Hunter Power Project Response to Submissions

Submissions Report

4 August 2021

Project No: IS354500
Document Title: Submissions Report
Revision: Rev 0
Date: 4 August 2021
Client Name: Snowy Hydro Limited
Project Manager: K Ivanusic
Author: C Whyte, A Horan, M Luger, C Whyte, A Horan
File Name: IS354500_Hunter Power Project EIS_SubmissionsReport_Final

Figure 1 NSW Reliability Shortfall shown in the AEMO 2018, 2019 and 2020 ESOOs

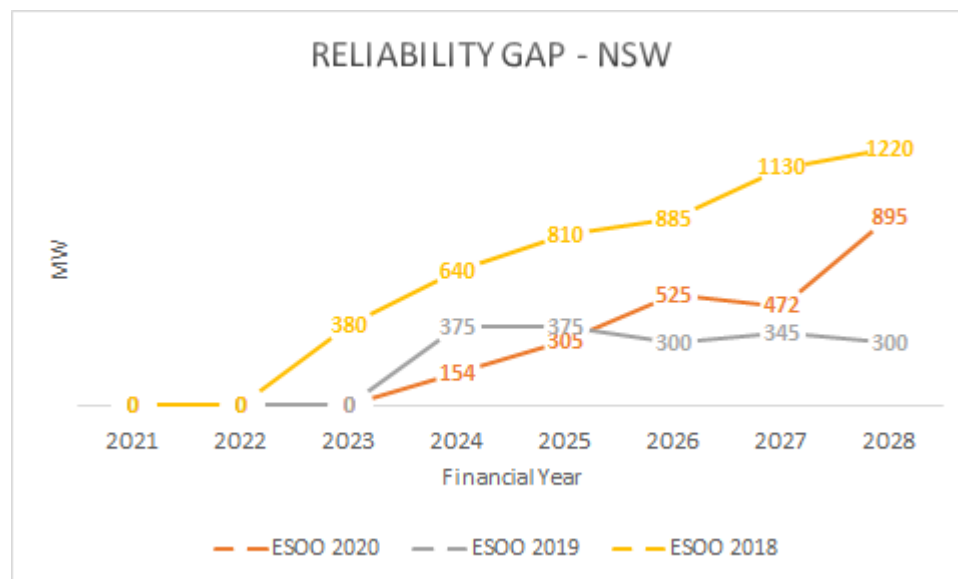
Although a number of submissions queried there was a sufficient shortfall in electricity for this Proposal, the capacity proposed of up to 750 megawatt (MW) is within the capacity shortfall forecast by Australian Electricity Market Operator (AEMO) in the Interim Reliability Measure and the AEMO Integrated System Plan (AEMO, 2020b). Addressing this shortfall is required to enable reliable operation of the NEM and reliable electricity supply to consumers. The increasing reliability shortfalls in NSW shown in the 2020 AEMO Electricity Statement of Opportunities (154MW in 2023-24 increasing to 2,045MW by 2029-30) reflect issues that include the closure of Liddell Power Station, the absence of Humelink, and the reducing reliability of coal power stations.

Response 6	<p>A strong theme throughout the submissions disputing the justification for the Proposal because of the reliability shortfall resulting from the closure of Liddell Power Station.</p> <p>It is important to identify that the 154MW figure often used is the shortfall identified for the 2023-2024 year in the AEMO 2020 Electricity Statement of Opportunities (AEMO, 2020a), as the forecast reliability gap to meet the Interim Reliability Measure for extreme events. In the 2020 ESOO this figure increases from 154MW in 2023-24, to 305MW in 2024-25 to 2,000MW by 2029-30, describing an increase in the reliability shortfall. These scenarios exclude consideration of the Hunter Power Project. As such, using 154MW to describe the reliability shortfall is a misuse of that figure, with AEMO's ESOO clearly identifying a reliability shortfall in the NEM that needs to be addressed for a reliable power system. It is also noted that the reliability figures are based on AEMO's P10 modelling, meaning 10% of their modelled scenarios require more than the capacity identified (e.g. 305MW in 2024-25). Having a power system that is short on capacity 1 in 10 days is not desirable.</p> <p>The figure below illustrates the progressive change in the reliability gap of capacity required to meet the reliability standard under a scenario of 10% PoE for unserved energy ("USE") i.e. $USE \leq 0.0002\%$. Specifically, whilst the trend shows some reduction in the gap in the early years the progressive year-on-year forecast clearly demonstrates an emerging reliability gap in NSW. Crucially, the inclusion of Snowy 2.0 has no impact on these early years, given the commissioning schedule across financial year 2026. Moreover, in later years, Snowy 2.0 has negligible impact on these outcomes without associated transmission being committed, specifically Humelink.</p>

Accordingly, NSW remains highly exposed during the period from Liddell retirement to the commissioning of Snowy 2.0 which is highly dependent on Humelink approval. The increasing reliability shortfalls in NSW shown in the 2020 ESOO (154MW in 2023-24 increasing to 2,045MW by 2029-30) reflect issues that include the closure of Liddell Power Station, the absence of Humelink, and the reducing reliability of coal power stations.

Figure 1: Significant excavation locations

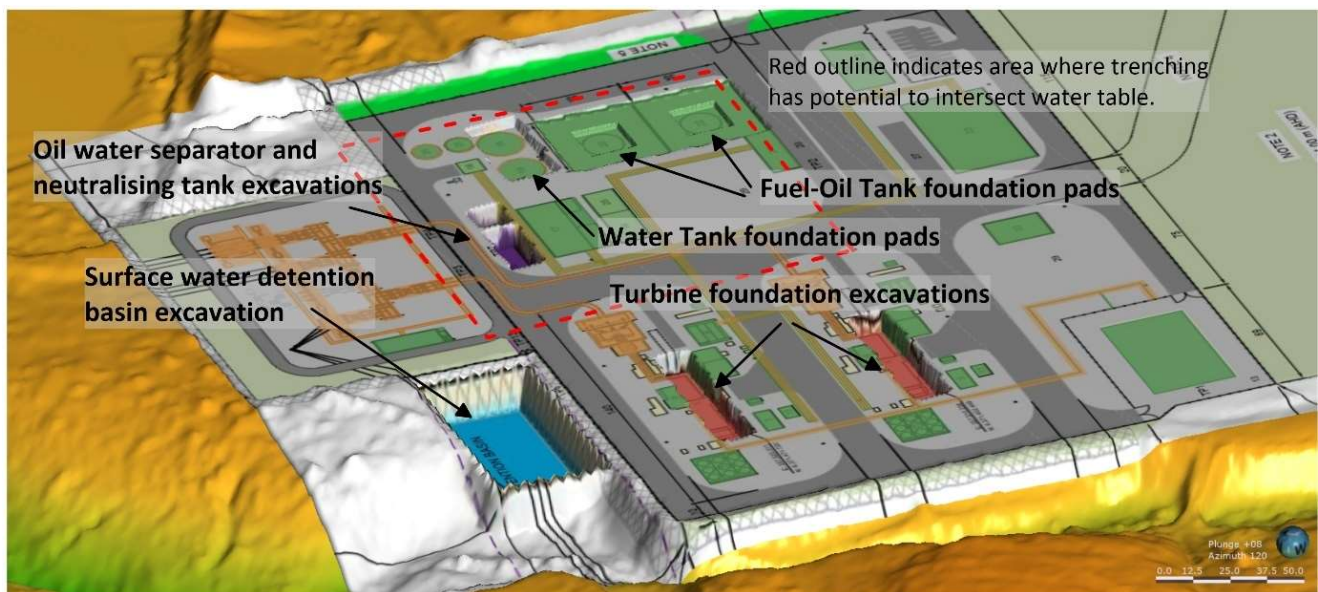
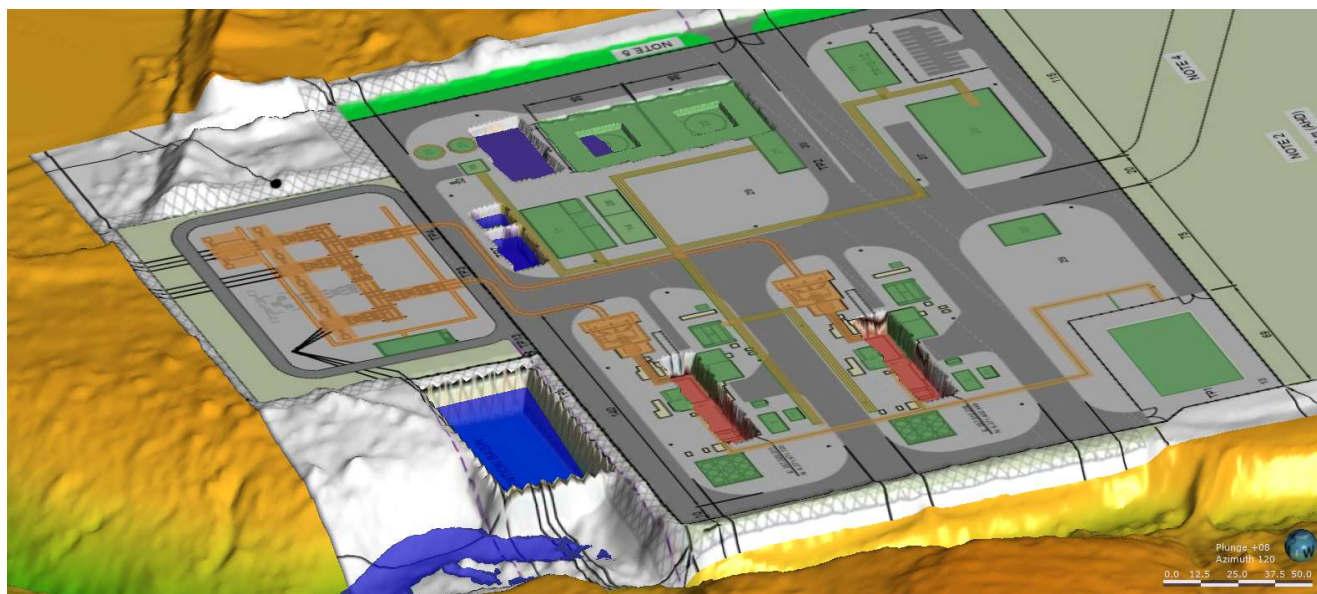
DPIE Water notes that a quantified estimate of groundwater inflows during construction was not provided, however, information presented in Table 12.3: Groundwater mitigation measures, suggests the proponents is planning a subsequent body of work, potentially including a dewatering plan. This suggests the proponent does not currently have sufficient confidence in the estimate of the volume of take to adequately assess potential impacts during construction. The proponent intends to adopt 'means to minimise water ingress during construction' of a stormwater basin and other services with potential for intercepting groundwater.

DPIE Water and NRAR recommend prior to approval that the proponent should demonstrate a reasonable quantified estimate of groundwater take for the proposed development. The proponent should refer to the Sydney Basin-North Coast Groundwater Source of the Water Sharing Plan for the North Coast Fractured and Porous Rock Groundwater Sources 2016 in the Response to Submissions and any future documents.

Selected significant indicative excavations are depicted on Figure 1. On Figure 2 the indicative excavations are superimposed on the water table showing the water table (blue opaque surface) daylighting in the deeper excavations (surface water detention basin and oil-water separator tank and neutralising tank).

The northern most fuel oil tank foundation excavation has potential to intersect water table in the northern half of the excavation; however, the depth below water table (<0.05 m) is not sufficient to warrant assessment of dewatering. The water tank foundations excavation also has potential to intersect the water table, with indicative average depth below water table of approximately 0.05 m.

Figure 3 Groundwater Drawdown

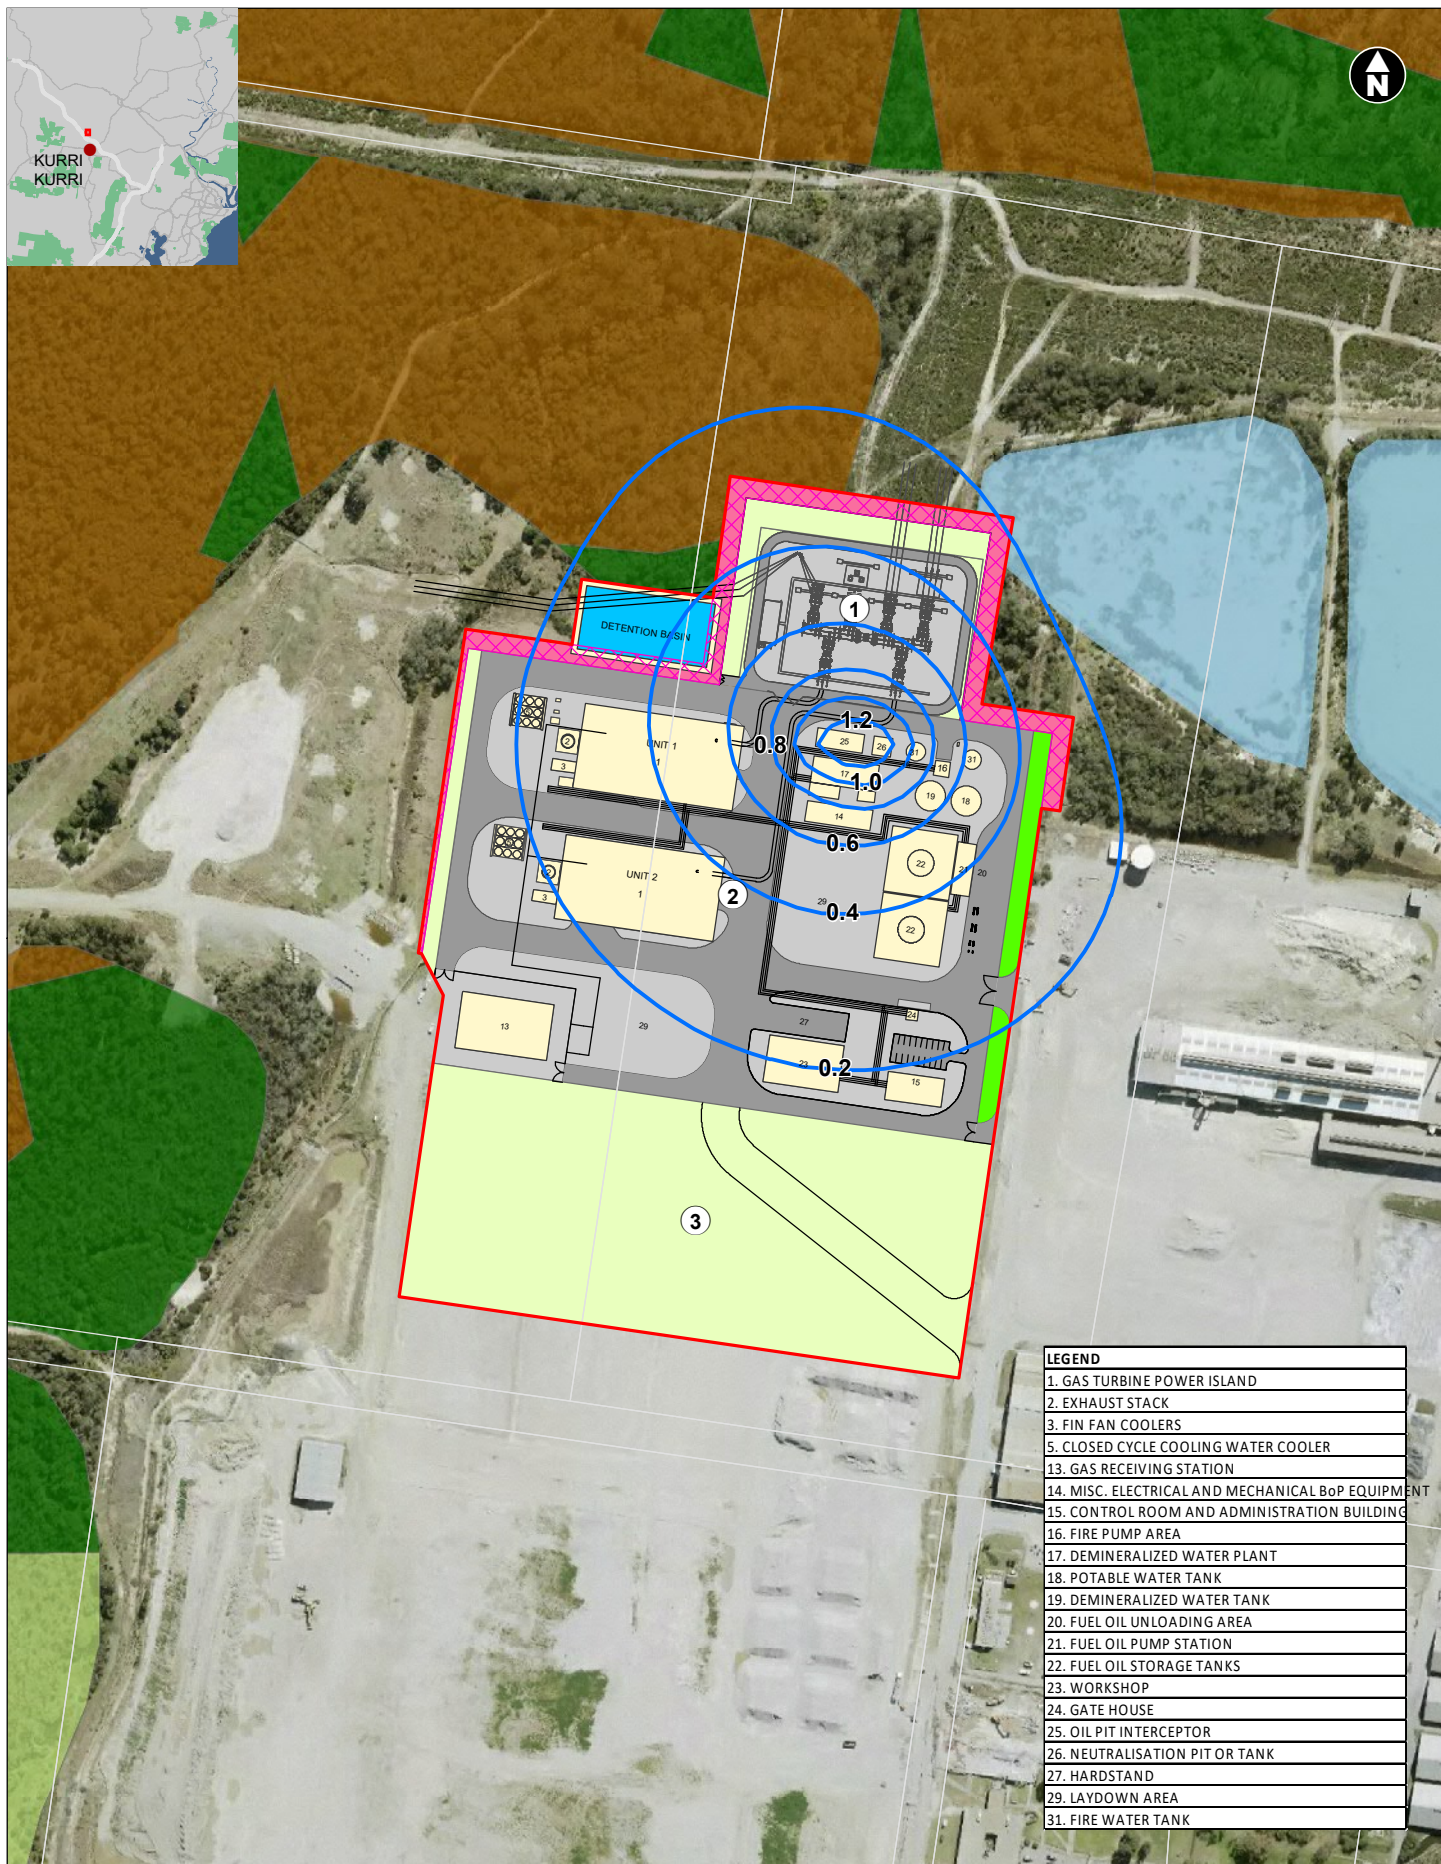
DPIE Water and NRAR recommend prior to approval that after demonstrating a reasonable quantified estimate of groundwater take (as recommended in section 1.0 Groundwater Take above) that the proponent provide additional evidence to support an assessment of the impacts of proposed take against the minimal impact considerations of the NSW AIP and rules of the relevant Water Sharing Plan.

Based on the worst-case scenario with no controls, water ingress into excavations could result in dewatering of 1.3 ML. Under this worst-case scenario, the predicted cone of drawdown falls predominantly within the Proposal Site (see Appendix E). The extent and magnitude of predicted drawdown outside of the Proposal Site is not considered to be significant. Following the brief period of construction dewatering, water levels will recover with no long-term or residual drawdown anticipated. An assessment against the AIP and Water Sharing Plan is provided in the Water Quality and Aquatic Ecology Addendum (refer to Appendix E).

From Figure 3, the predicted cone of drawdown from dewatering for the oil-water separator and neutralising tank excavations falls predominantly within the Proposal Site. Drawdown propagation, as represented by the 0.2 m drawdown contour, is predicted approximately 170 m north of the excavation, and less than 50 m north of the
